Berrima Resident

This is a personal submission of objection for Berrima Rail Project (7171) – a State Significant Development for Mining

# Attachment 1 - BioNet records of Paddys River Box where rail crosses Berrima Road

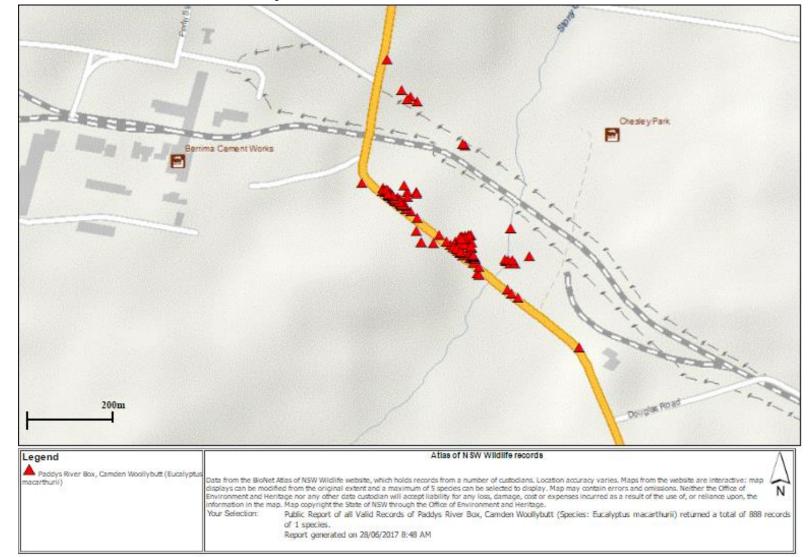
The EIS claims that if the preferred option is selected, there will be impact to one Paddys River Box tree (see EIS Fig. 12.8). Records of Paddys River Box are publicly accessible on BioNet. Where the proposed rail line crosses Berrima Road, there are approx. 100 Paddys River Box records on BioNet (Attachment 1).

The preferred & alternative options and the construction buffers are within the same space and directly adversely affect around 50 of the recorded Paddys River Box in Attachment 1.

According to the EIS, only *Sixteen individual Paddys River Box were recorded in the study area, with an additional 24 individuals recorded to the south west*. Furthermore, according to Figure 12.4 inset 2 there are only 3 individuals detected west of Berrima Road and 7 individuals detected growing along Stoney Creek. How did they fail to detect the approx. 100 additional trees growing along Berrima Road?

They claim that the design has been modified such that any direct impacts to the species will be avoided. The DP&E is urged to compare Attachment 1 with Fig. 12.4 (insert 2) and determine if their claim is accurate. How will this affect the BioBanking calculations – see EIS Appendix J table 3.6 and table 6.2. They have only calculated credits for one Paddys River Box – yet should be calculating for potentially up to 50 Paddys River Box.
